GOVERNMENT OF TELANGANA  
FOREST DEPARTMENT

The Prl. Chief Conservator of Forests,  
(Head of Forest Force)  
Telangana State,  
"Aranya Bhavan" Saifabad,  
**HYDERABAD.****Rc.No. 1990/2020-M6, Dt. 17.08.2022.**

**Sub :-** TSFD-F(C) Act, 1980- Diversion of 0.521 Ha of Forest Land for Construction of BT Road from Kamana to Serkepalli from Km 0/0 to 8/920 of Wankidi Mandal, Garlapet (Part) RF of Asifabad Forest Division of Kumuram Bheem-Asifabad District in favour of Executive Engineer, R&B Division, KB -Asifabad - **Additional Information sought for by IRO, Hyd - Report submitted -Reg.**

### Cross Section Details

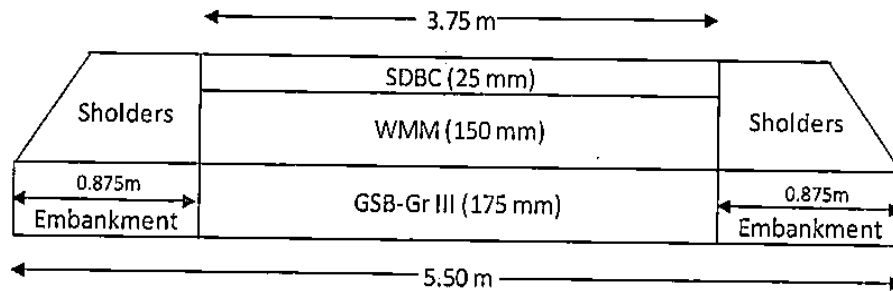
Design/cross section of the proposed road clearly indicating the width of carriage way (BT portion), shoulders/ Berm / drainage etc may be furnished.

**Reply:** Road designed with CBR 3.55% and Traffic (T3). And below cross section will explain width and thickness of carriage way (BT portion), Shoulder/Berm/Drainage.

### Cross Section Details

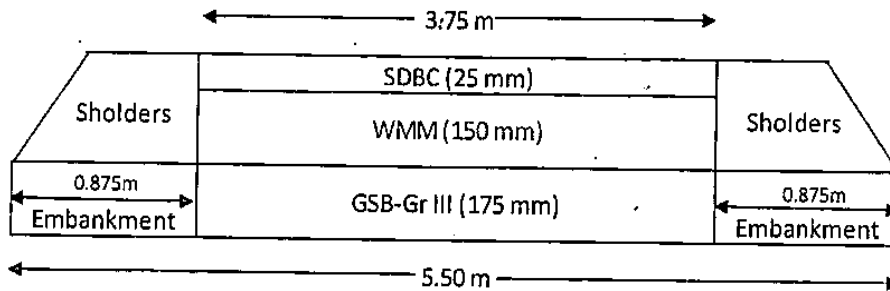
Design/cross section of the proposed road clearly indicating the width of carriage way (BT portion), shoulders/ Berm / drainage etc may be furnished.

**Reply:** Road designed with CBR 3.55% and Traffic (T3). And below cross section will explain width and thickness of carriage way (BT portion), Shoulder/Berm/Drainage.
